TO: Mercedes-Benz Dealer Principals, General Managers, Sales Managers, Service Managers, Parts Managers	FROM: Thomas Brunner, Department Manager, Vehicle Compliance and Analysis, Engineering Services
RE: <b>Service Campaign 2016010010, Model 117 (CLA), Model Year 2015. Check Air Ducts Under Instrument Panel, Retrofit if Necessary</b>	DATE: February 19, 2016

Campaign No. 2016010010, February 2016

SUBJECT: **Model 117 (CLA), Model Year 2015**  
**Check Air Ducts Under Instrument Panel, Retrofit if Necessary**

**Figure 2**

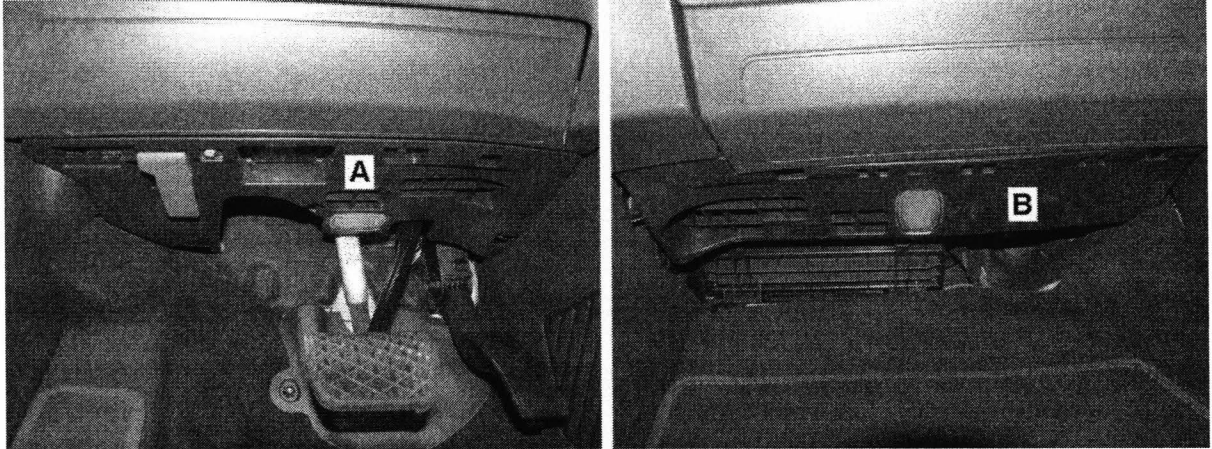
2.  Check if air ducts (C and D, Figure 2) are present below left and right side of instrument panel:
  - If air ducts (C and D) are present: Reassemble in reverse order; **Procedure is complete.**
  - If air ducts (C and D) are **not** present: Proceed to step 3.

3.  Retrofit missing air ducts (C and D, Figure 2) then reassemble in reverse order.  
 Air ducts (C and D) can be installed from below instrument panel without additional disassembly.

**Figure 1**

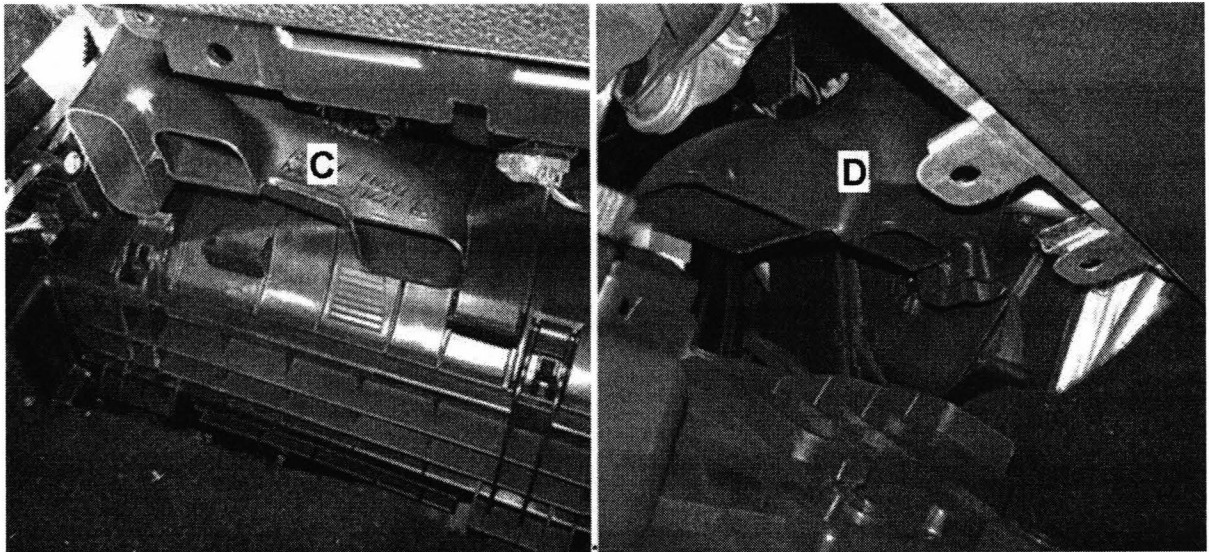
1.  Unfasten panels (A and B, Figure 1) below left and right sides of instrument panel and place to one side with lines connected, refer to WIS: AR68.30-P-4010NKB.

Do not disconnect: Hood release cable and electrical connectors from panels (A and B).
